ADDENDUM NO. 1 - Hillcrest Project

ADDENDUM NO. 1: DATED SEPTEMBER 24, 2004, TO BIDDING DOCUMENTS FOR CITY OF LYNCHBURG HILLCREST AVENUE SEWER REPLACEMENT, CITY PROJECT NO. 03076-S, COMM. NO. 204096.00.

FROM: WILEY & WILSON, INC.
ARCHITECTS • ENGINEERS • PLANNERS
LYNCHBURG, VIRGINIA

**HILLCREST AVENUE
SEWER REPLACEMENT**
STA 0+00 TO STA 9+00

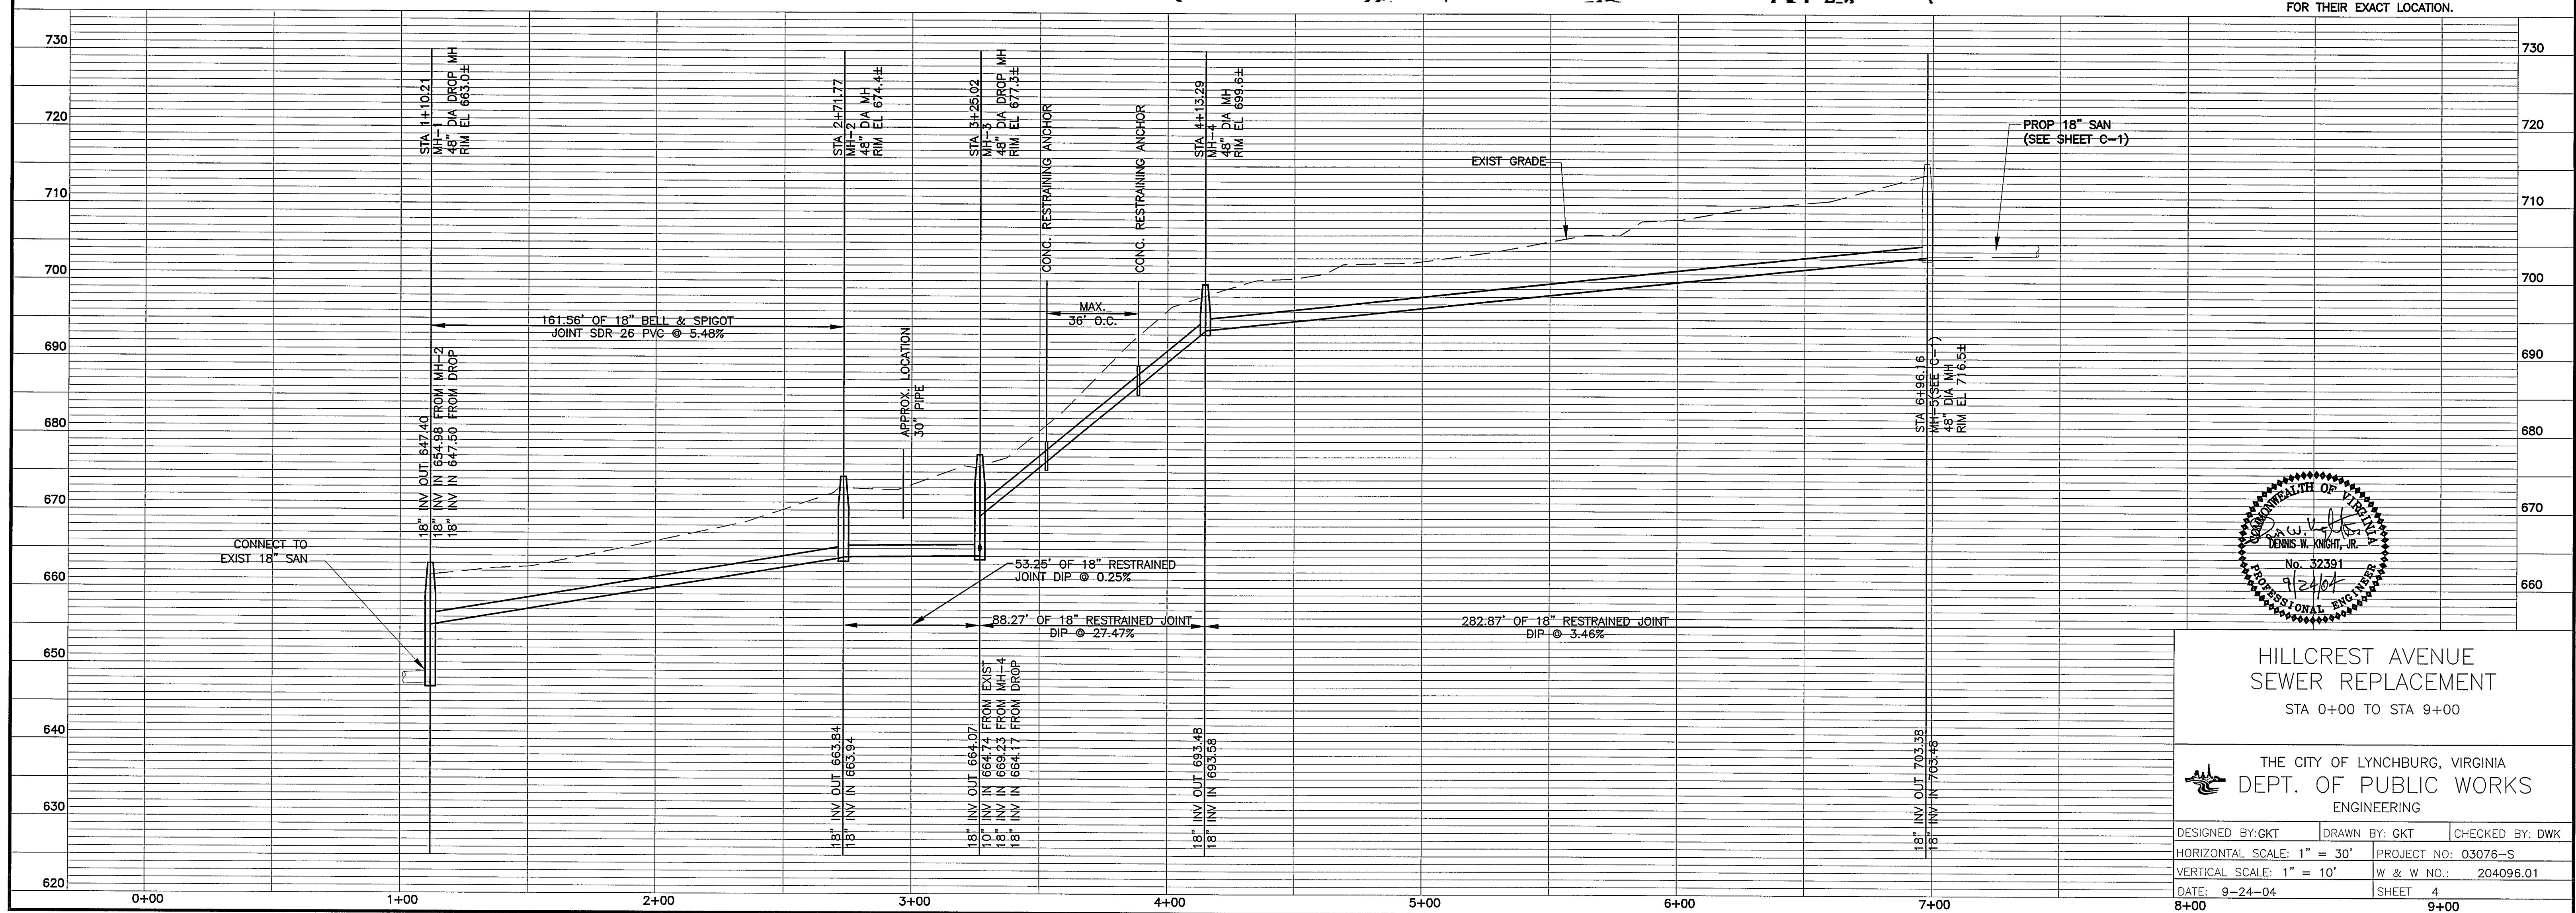
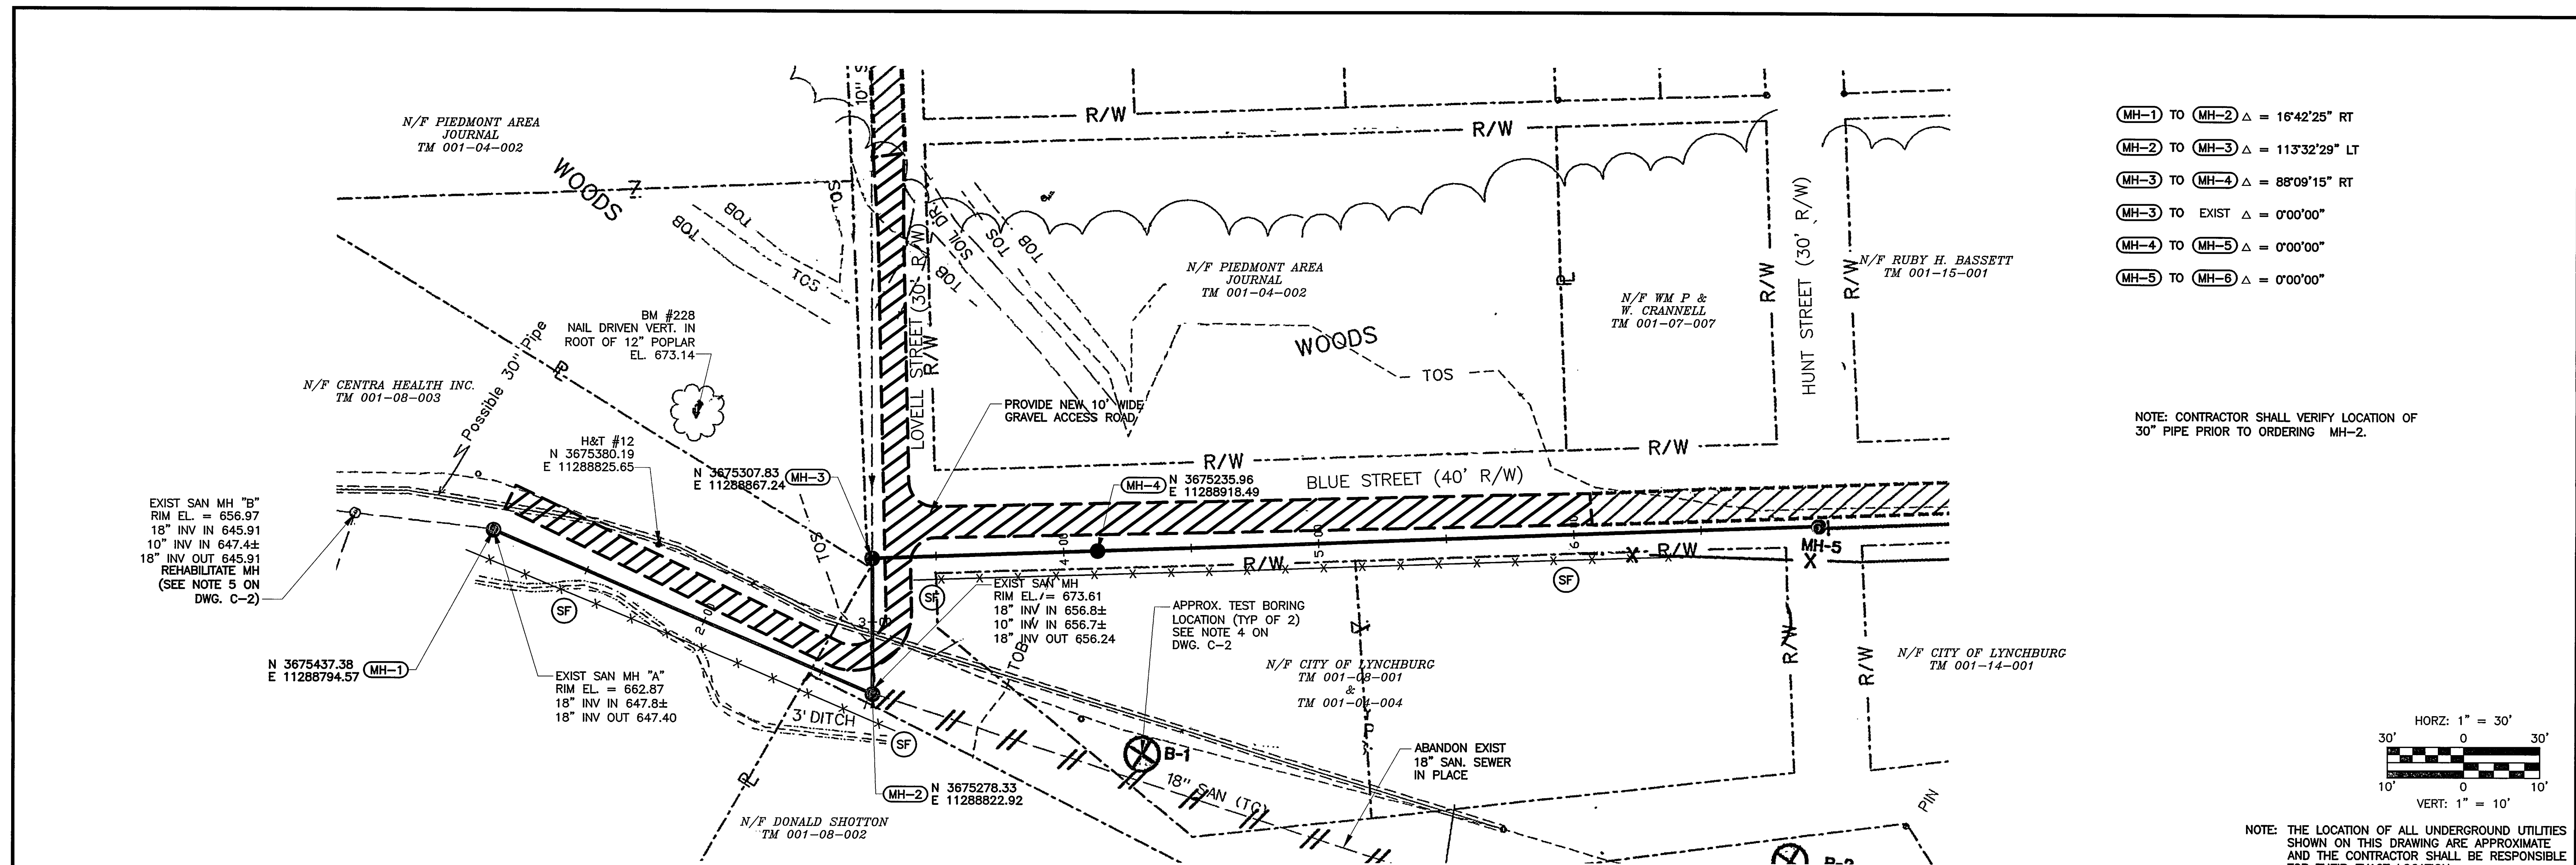
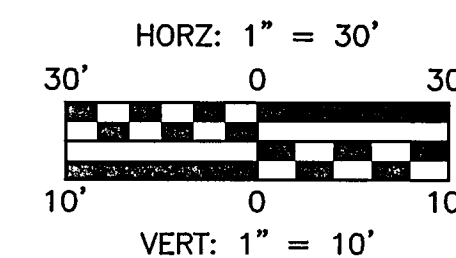
2. DRAWING C-1, SHEET NUMBER 2 OF 3:
 - A. THE SANITARY SEWER ALIGNMENT FROM MANHOLE 1 (STATION 0+00) TO MANHOLE 5 (STATION 6+96.16) HAS BEEN REVISED. DELETE THE ALIGNMENT FROM MANHOLE 1 TO MANHOLE 5 SHOWN ON SHEET C-2 AND REPLACE WITH THE REVISED ALIGNMENT AS INDICATED ON THE ATTACHED DRAWING, SHEET 4.

NOTE: CONTRACTOR SHALL VERIFY LOCATION OF 30" PIPE PRIOR TO ORDERING MH-2.
